STAFF ANALYSIS

Case No.:	CZ-25-1247294	File ID #: 2024-1442	
Address:	1716 Pleasant Hill Trail, 7778, 7860, 7890, 7900, 7956 & 8024 Pleasant Hill Road	Commission District: 05	Super District: 07
Parcel ID(s):	16-197-03-006, 16-197-03-012, 16-219-01-005, 16-219-01-006, 16-220-01-004 16-220-01-007 & 16 220 01 009		
Request:	Major modification of Conditions #1 and #4 of CZ-18-22130 for the development of single-family detached dwellings within the RNC (Residential Neighborhood Conservation) Zoning District.		
Property Owner(s):	Hybrass Properties, LLC.		
Applicant/Agent:	Hybrass Properties, LLC. c/o Battle Law, P.C.		
Acreage:	95.52 acres		
Existing Land Use:	Single-family dwellings/vacant		
Surrounding Properties:	North: R-100, MU-1 East: RNC, R-85 South: R-85 West: R-85		
Comprehensive Plan:	Suburban (SUB)	Consistent	Inconsistent X

Staff Recommendation: TWO-CYCLE DEFERRAL

CONCEPT PLAN
FOR
PLEASANT HILL

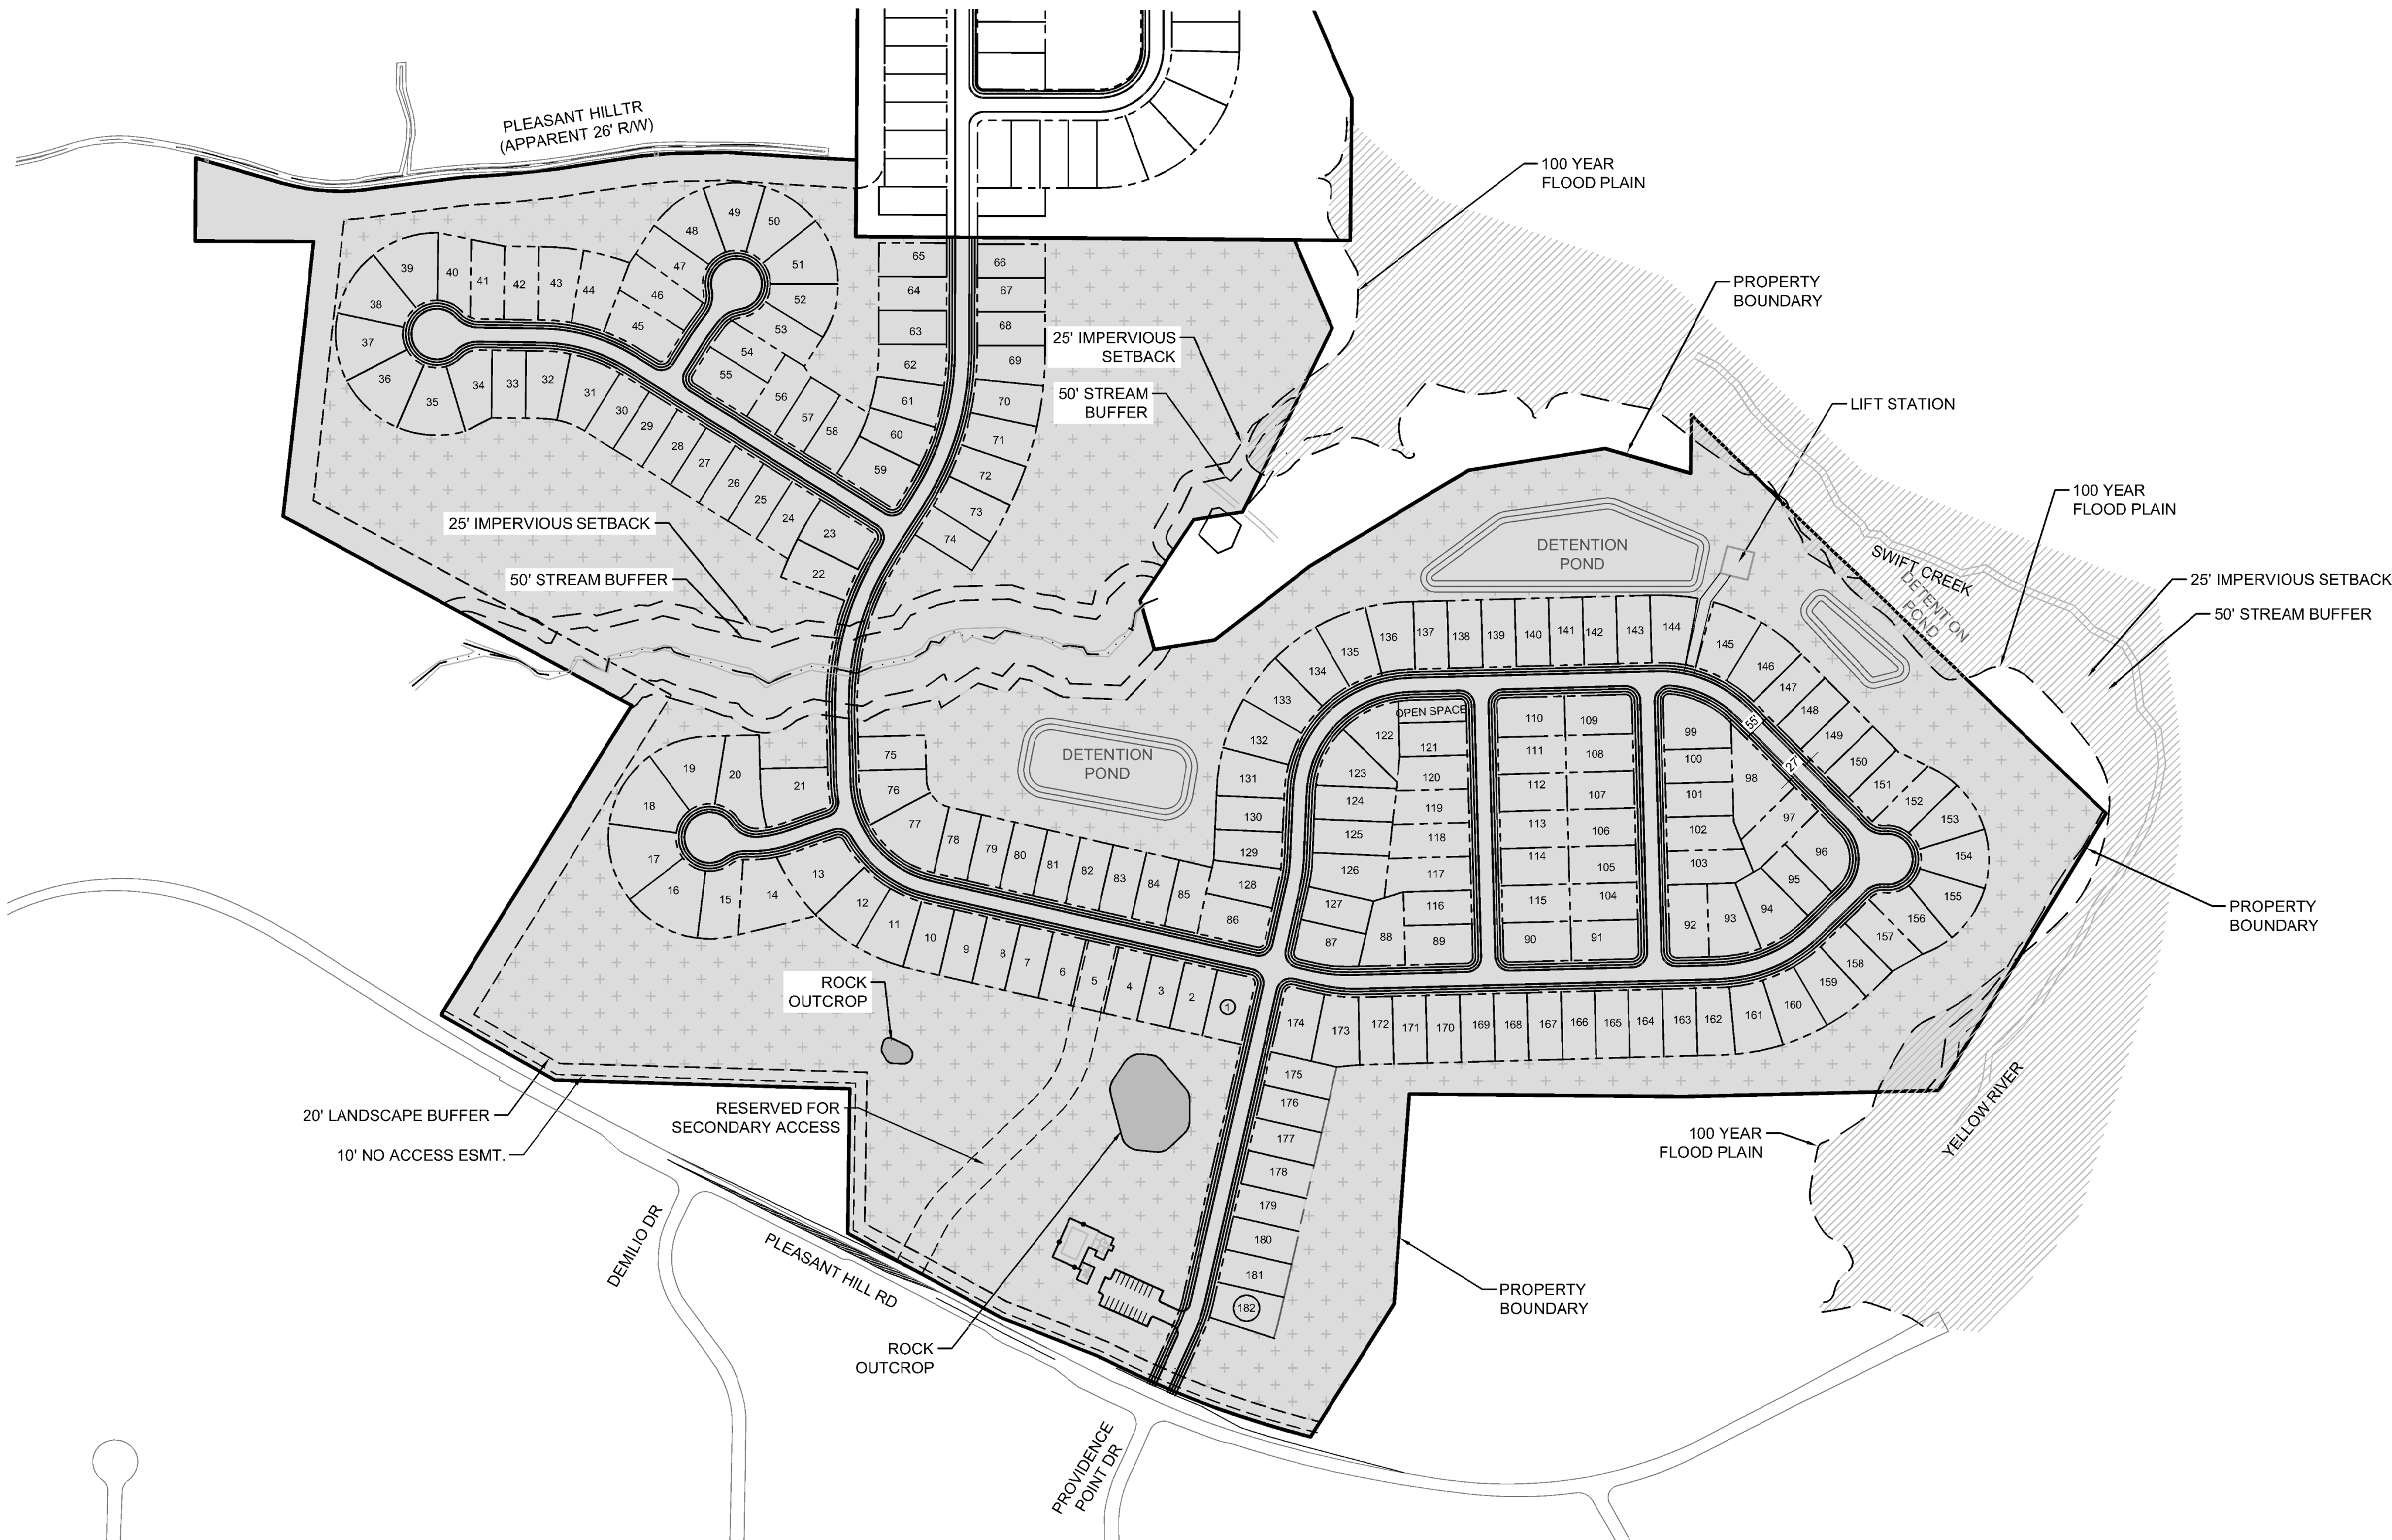
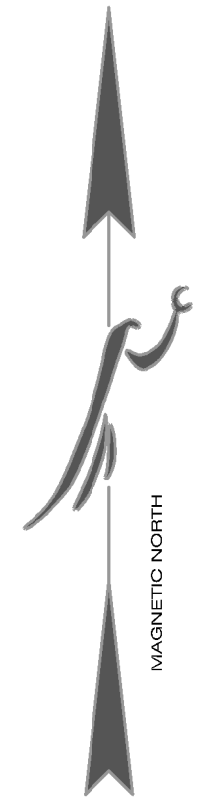
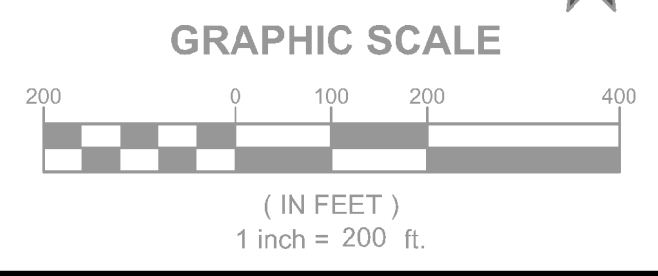
A modification of Condition #4 would relocate the originally proposed access points along Pleasant Hill Road to accommodate topography. One of the access points would connect to a proposed subdivision to the north of the development site; notably, however, Current Planning has yet to have received a Sketch Plat application for such a subdivision. An additional access point would be provided only for emergency vehicles. Per the current site plan, only (1) of the three (3) access points would be for regular traffic off of Pleasant Hill Road, which has raised concerns from Staff as well as the surrounding community.

While the reduction of units allows for the potential preservation of greenspace that is encouraged with RNC developments (see Section 2.10.2. of the *Zoning Ordinance*), there are still potential issues with topography that may affect the configuration and/or potential lot yield with the development. Namely, the new site plan does not appear to prove compliance with the minimum greenspace requirement as defined per Section 2.10.5. of the *Zoning Ordinance*. A minimum of 30 percent of the total site area shall be dedicated to greenspace, which may not consist of the following features (per Section 2.10.5.(B)):

The submitted site plan shows a development that appears to have extreme slopes throughout, as well as having state waters/stream buffers. Meeting this greenspace requirement could pose a challenge for development and could affect lot yield.

N5. CZ-25-1247294 - 7778 Pleasant Hills Road, etc. - Phase 1 has 182 lots and requires 3 access points (Sec. 14-200 (5)). Verify the reserved secondary access point meets the minimum spacing outlined in 14-200 (6) and has the required sight distance. Please see infrastructure requirements in Zoning Code 5.4.3 and Land Development Code 14-190. Pleasant Hill Road is a classified as a minor arterial (45MPH). Requires a right of way dedication of 40 feet from centerline OR such that all public infrastructure is within right of way, whichever greater. Requires at least an 11-foot travel lane with curb and gutter. Requires a 10-foot landscape strip (with at least 5 feet between the back of curb and the sidewalk/path), 6-foot sidewalk with 4-foot bike lanes OR (preferred) 10-foot multiuse path in lieu of sidewalk and bike lane. Street Lighting required. (hefowler@dekalbcountyga.gov). Pleasant Hill Road is classified as a local road. Requires a right of way dedication to 27.5 from centerline OR such that all public infrastructure is within right of

As a result of meetings with Current Planning Staff, the applicant has requested a deferral of the proposal to revise their site plan and provide additional information. In coordination with the applicant's request, the Planning and Sustainability Department recommends a *Two-Cycle Deferral* to address the above issues.
